RE: DA2015/138 - Proposed Coastal Protection Works – 3 & 5 Camden Lane and 2 Skinner Street, Ballina

8.4 **DA 2015/138 - Coastal Protection Works, Skinner and Camden Streets.DOC**

Civiltech Consulting Engineers, Drawing No. 1284-DR1 Issue J, Sheet No. 1 of 2 Dated 12 June 2015.

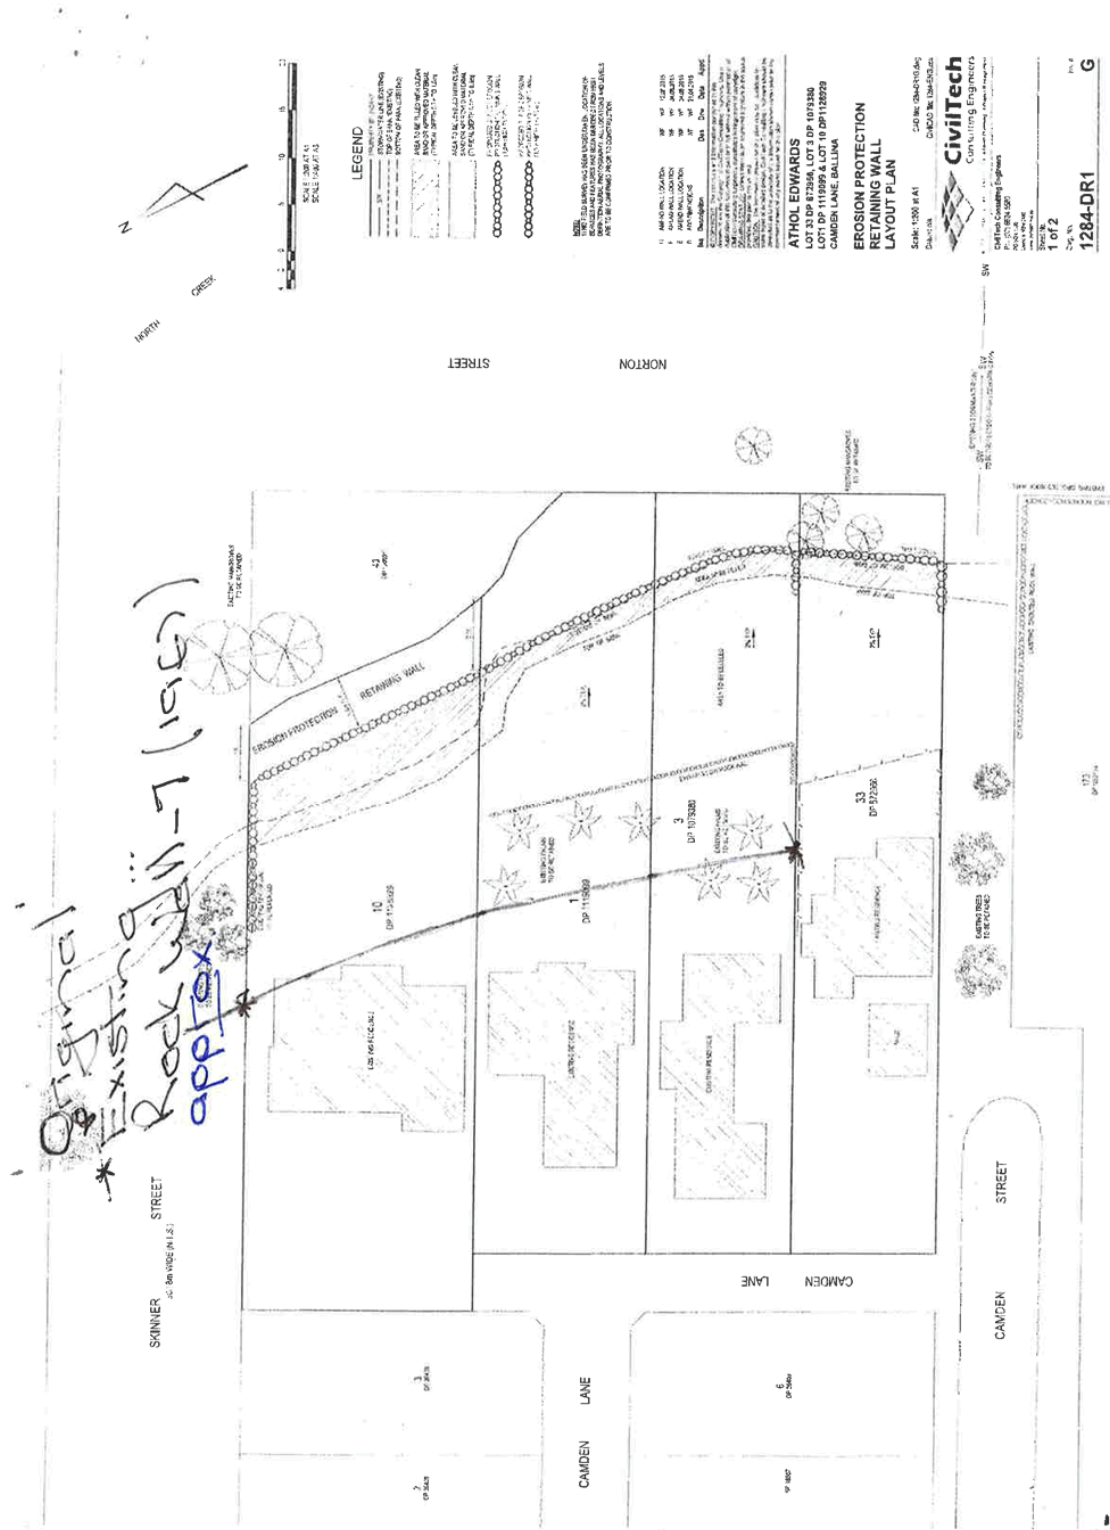
The thing is that even these latest plans / drawings by CivitTech fail to show or label the initial rock - erosion control sea wall that was in place in the early 60s, and that was substantially upgraded in probably 1967 after tail end of a cyclone or rough early winter storms, even in North Creek as it was then, on its old course around the Serpentine to the oyster sheds.

As per my addition to version 3 of the amended plans, attached, this seawall must have been on an alignment of say 8-10mtrs to the east of all 3 residences along that stretch of the North Creek Foreshore, and you would assume was placed along the Mean High Water - MHW, for those times and local knowledge

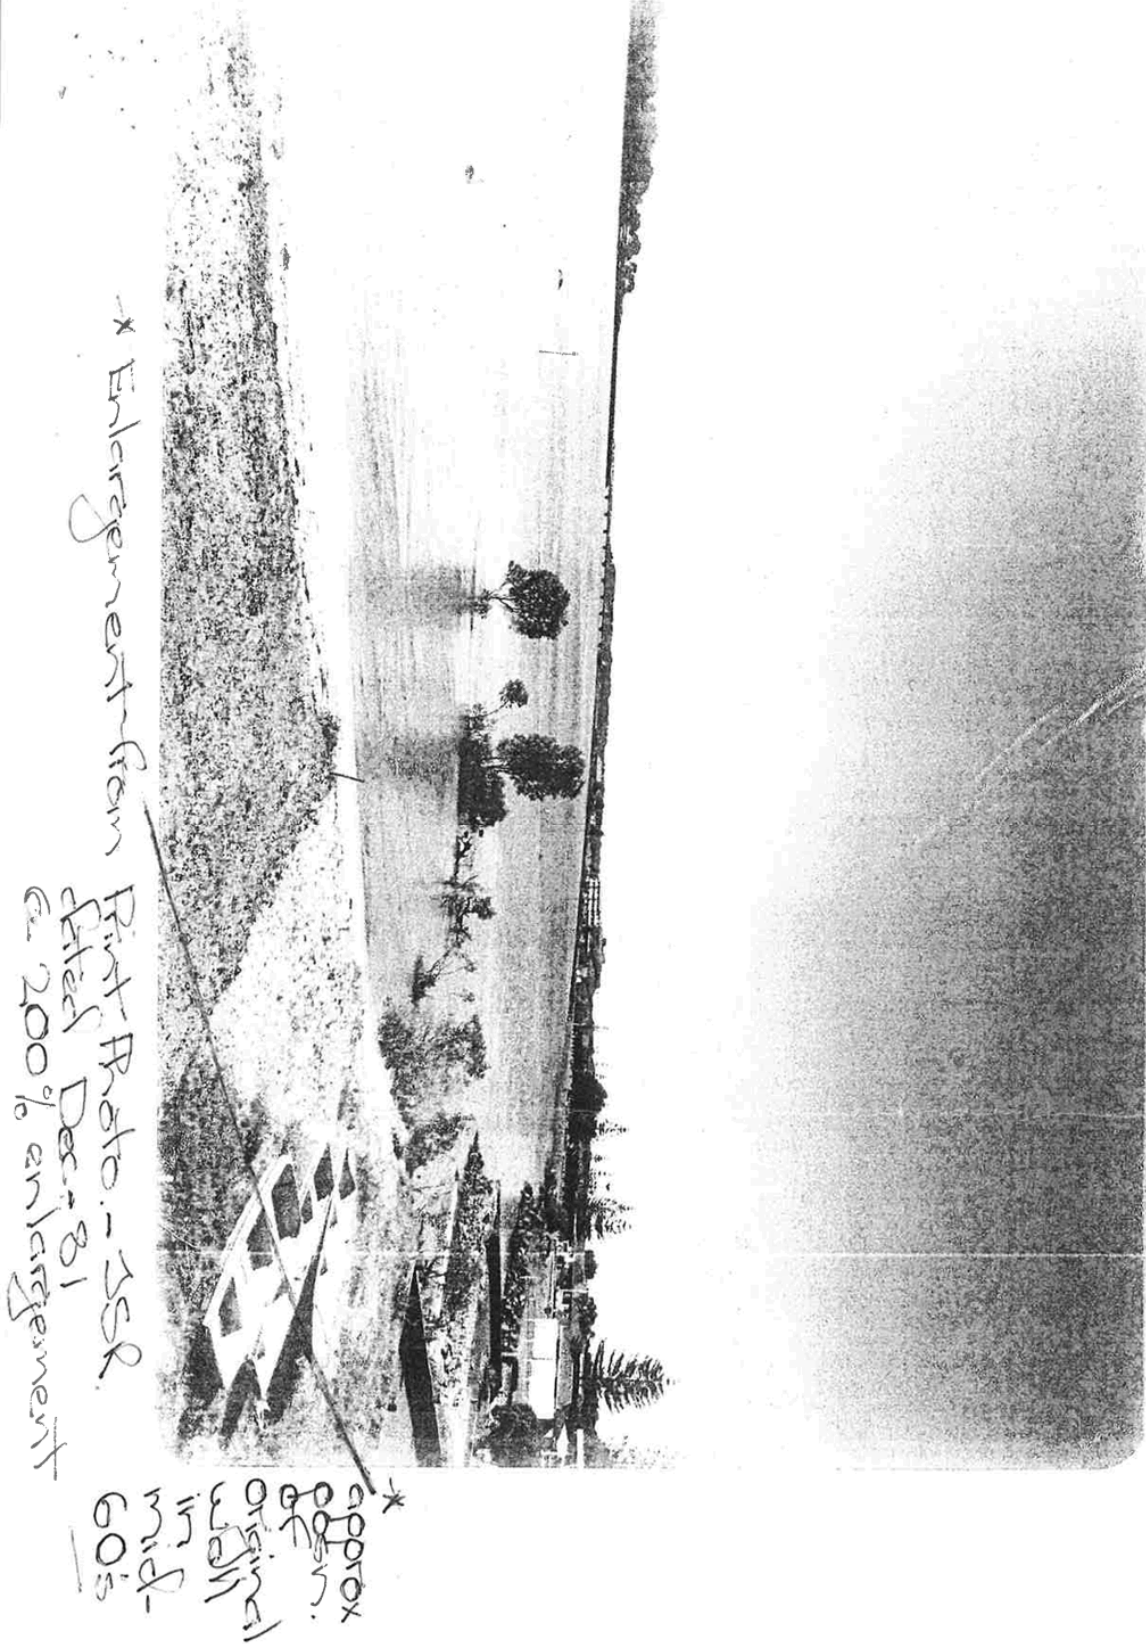
I refer to our recent discussions regarding the abovementioned development application and wish to advise that the proposal is to be amended to reduce the scale of the proposed coastal protection works. In this regard, please find attached three (3) copies of the amended plan for Council's consideration. The amendments are proposed with consideration to comments by Council and by a small section of the community. The location of the proposal is fully within private land and the removal of the mangroves is now not proposed.
